ENGINE - FUEL AND CONTROL - SELECTIVE REPROGRAMMING OF THE DATA ENTRY PLUG ASSEMBLY -
CATEGORY CODE 4 - MOD.ENG-73-0013

V2500-ENG-73-0013

Data Entry Plug Assembly
Fig.1

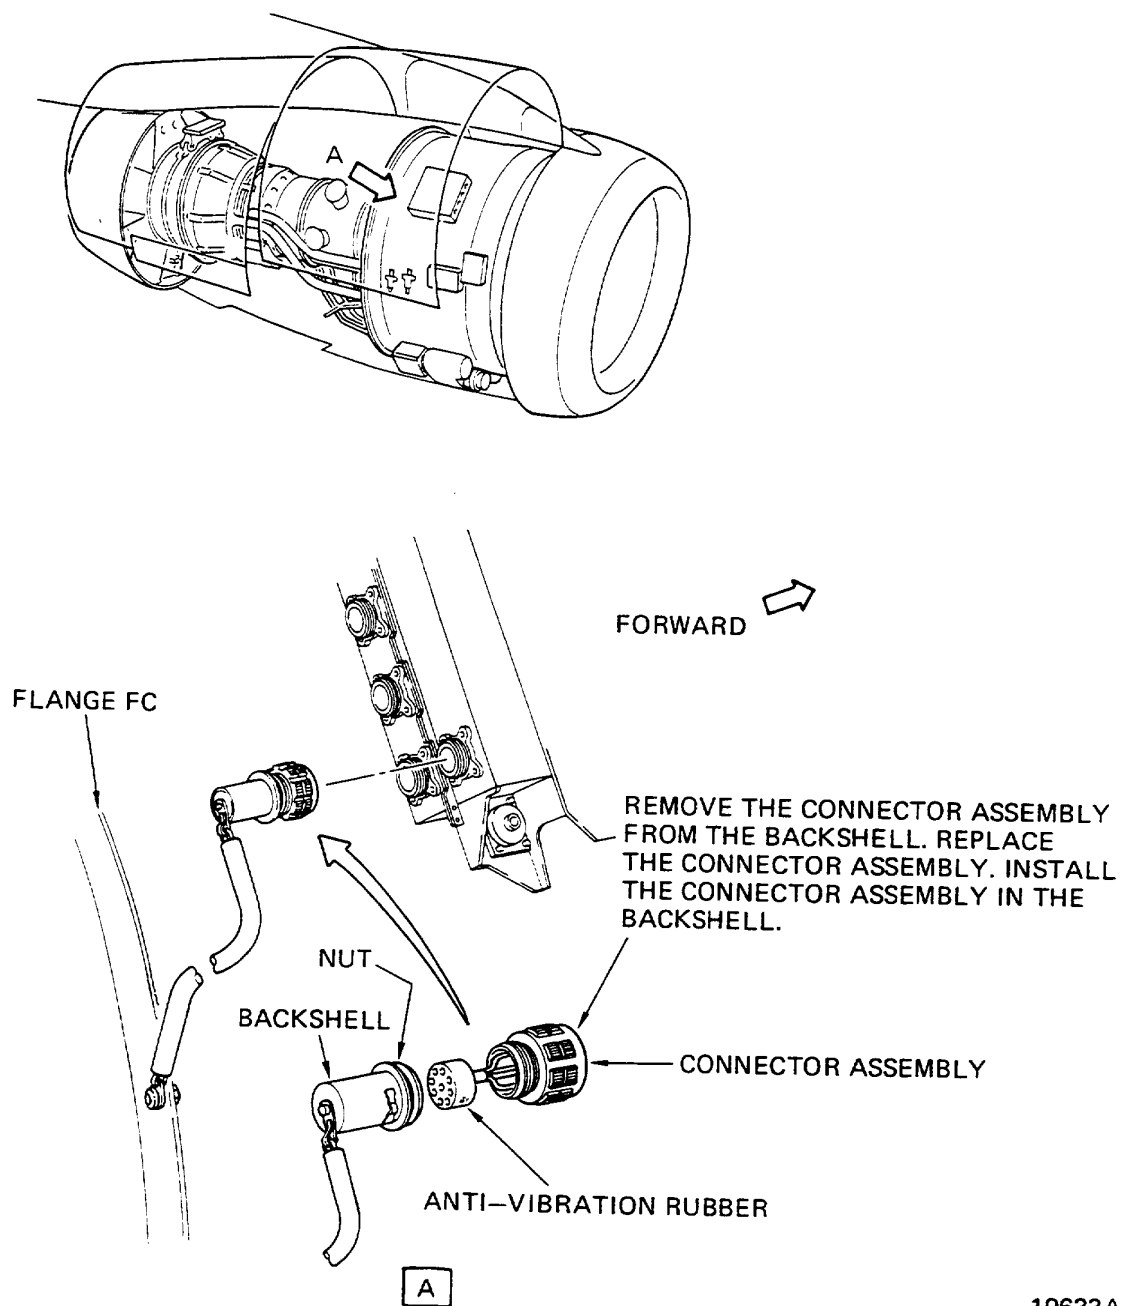
- (1) The engines with the incorrect EPR modifier class wired into the Data Entry Plug must be retrofitted. The engine with the incorrect engine serial number must be retrofitted to correct the engine identification for the aircraft system.

- (1) Remove the lockwire from the Data Entry Plug Backshell and Connector Assembly. Refer to Figure 1.
- (2) Remove the Connector Assembly from the Backshell.
- (3) Remove the Anti-Vibration Rubber from the Connector Assembly.
- (4) Replace the Connector Assembly.
- (5) Install the Anti-Vibration Rubber on the new Connector Assembly.
- (6) Install the Connector Assembly into the Backshell.
- (7) Tighten and torque the Backshell to 19 - 26 lbfin (2,147 - 2,938 Nm) with a strap wrench by use of the approved procedure in Reference (1), Chapter/Section 70-23-11, (TASK 70-23-11-911-012).

- (a) For engine serial numbers V0018 and V0022, change the Data Entry Plug Backshell EPR MOD. No. from 07 to 08.
 - (b) For engine serial numbers V0018 and V0022, change the Engine Identification Plate EEC PROGRAM PLUG from -07 to -08.

- (c) For engine serial numbers V0066, V0068 and V0088, change the Data Entry Plug Backshell EPR MOD. No. from 08 to 09.
 - (d) For engine serial numbers V0066, V0068, V0082 and V0088, change the Engine Identification Plate EEC PROGRAM PLUG from -08 to -09.

- (e) For engine serial numbers V0036, V0084 and C0086, change the Data Entry Plug Backshell EPR MOD. No. from 09 to 10.
 - (f) For engine serial numbers V0036, V0084 and V0086, change the Engine Identification Plate EEC PROGRAM PLUG from -09 to -10.

- (g) For engine serial number V0073, if applicable change the Data Entry Plug Backshell ENG. S/N to V0073.
 - (h) For engine serial number V0158, change the Data Entry Plug Backshell EPR MOD. No. from 06 to 07.

- (i) For engine serial number V0158, change the Data Entry Plug Engine Identification Plate EEC PROGRAM PLUG from -06 to -07.

- (1) Connect the Data Entry Plug Assembly to the EEC. Refer to Figure 1.
- (2) Tighten and torque the Plug Assembly to 32 lbfin (3,6 Nm). Use the IAE 1J12018 EEC Harness Wrench. See Reference (2), Chapter/Section 70-41-00, (TASK 70-41-00-400-501).
- (3) Tighten and torque the Backshell to 53 - 58 lbfin (5,99 - 6,55 Nm). Use a TG-70 Strap Wrench, or equivalent. See Reference (2), Chapter/Section 70-41-00, (TASK 70-41-00-400-501).
- (4) Safety the Backshell to the Connector with CoMat 02-138 Lockwire. See Reference (1), Chapter/Section 70-41-11, (TASK 70-40-11-911-012).
